**To:** Members of Dublin City Council  
**From:** Marsha I. Grigsby, City Manager *MA*  
**Date:** October 31, 2013  
**Initiated By:** Steve Langworthy, Director of Land Use and Long Range Planning  
Claudia D. Husak, AICP, Planner II  
**Re:** Final Plat – Links at Ballantrae (13-057FDP/FP)

13-057FDP/FP  
 Final Development Plan/Final Plat  
 The Links at Ballantrae  
 Rings Rd

**SPLIT-RAIL FENCE ELEVATION**

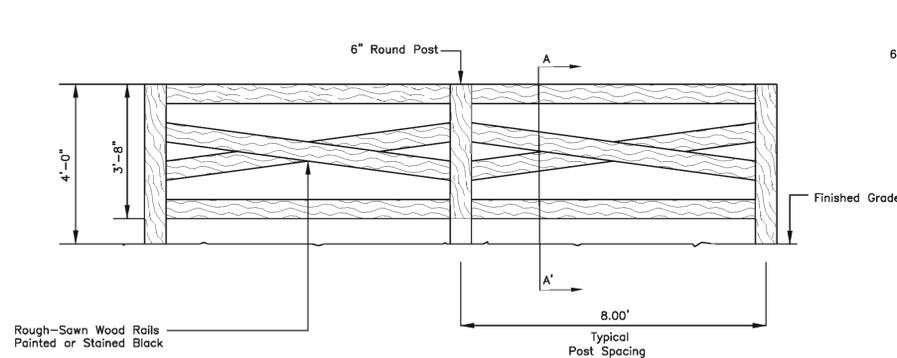
Mr. Taylor said he was not present for the preliminary development plan, but he noticed the fence was indicated at 4 feet 8 inches tall where 4-foot is permitted.

1. That the applicant revise the fence detail to a height of 4 feet, prior to submitting the final plat to City Council; and,
2. That the applicant continue to work with staff and the property owner on appropriately located landscape screening for 6800 Rings Road in terms of right-of-way location and visibility triangle requirements.

(A) Split Rail Fence

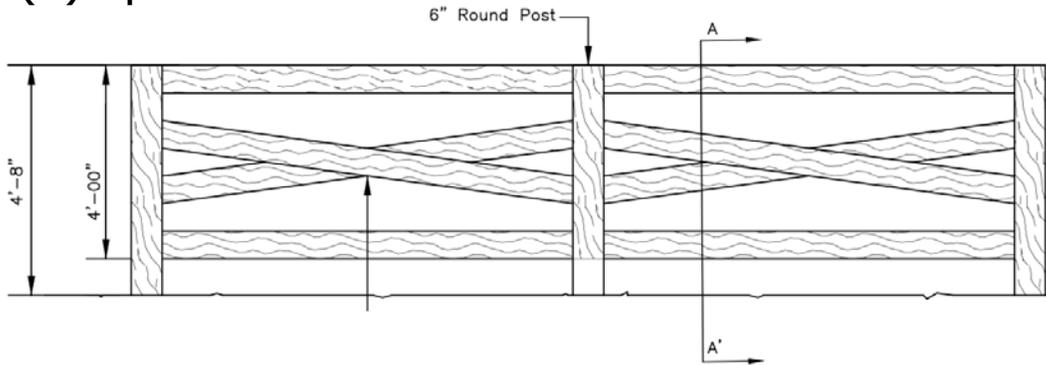
- 1) That the applicant revise the fence detail to a height of 4 feet, prior to submitting the final plat to City Council; and,
- 2) That the applicant continue to work with staff and the property owner on appropriately located landscape screening for 6800 Rings Road in terms of right-of-way location and visibility triangle requirements.
